**NUMBER:** 08-084-13

Decklid Opens Unintentionally

This bulletin involves inspecting the decklid passive entry switch and replacing if necessary.

2011 - 2013	LD	Charger
2011 - 2013	LX	300

**Fig. 1 Passive Entry Switch Button Surface**

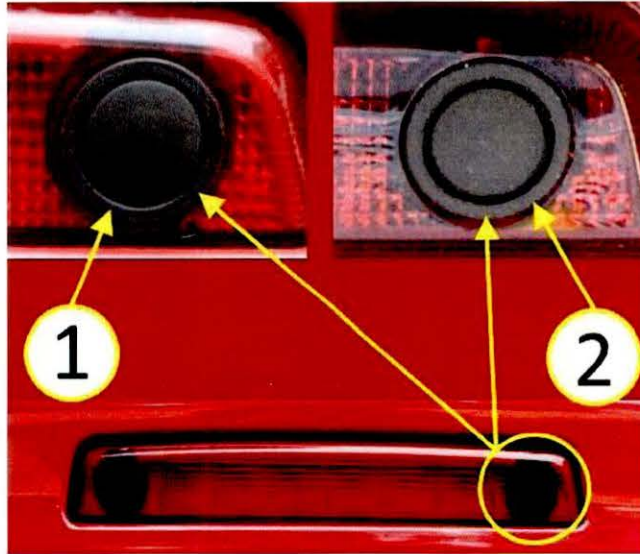
1. Determine if the trunk passive entry switch button surface is plastic (slippery) or rubber (grippy) by rubbing a finger across the switch button surface to detect the surface material. Appearance is very similar and may require careful examination to detect which version of switch is installed (Fig. 1).
  - a. Plastic (1) (Fig. 1) replace the switch, perform the repair procedure.
  - b. Rubber (2) (Fig. 1) no further action is required, return the vehicle to the customer.

**Fig. 4 Switch Version**

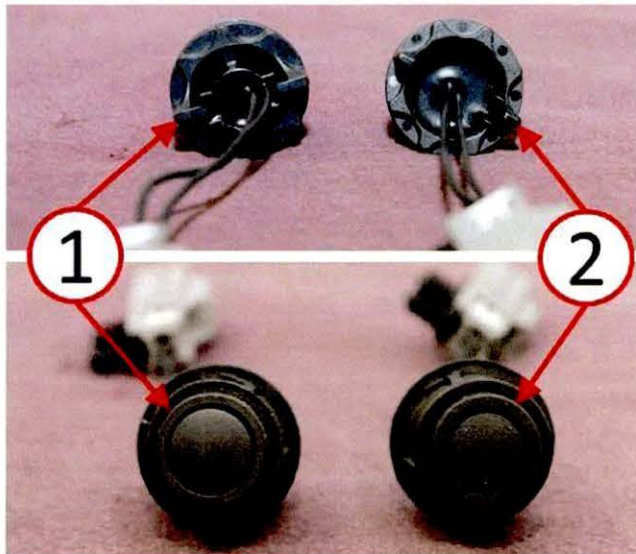
5. Replace previous version plastic button passive entry switch (1) with new version rubber button passive entry switch (2) (Fig. 4).
